Access Compliance Report Public Rights-of-Way (Curb Ramps)

Main Street: ETHEREAL_ST		Cross Street: MELODY_LN		Location:	SW
ADA ID: RPRK211027134103	Ramp Type: Type 4 - Parallel	Initial Pass/Fail: Fail	Overall Compliance: No	Severity Score:	2
Codes/Mitigation Info/Possible Solution			Field Measurements/Component Compliance

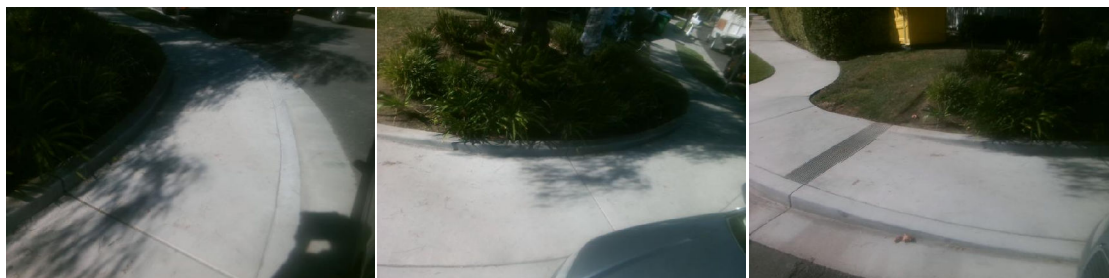
R204.3, R304.5.3, STD 1115

Remove & Replace Curb Ramp With Two New Directional Ramps or Equivalent.
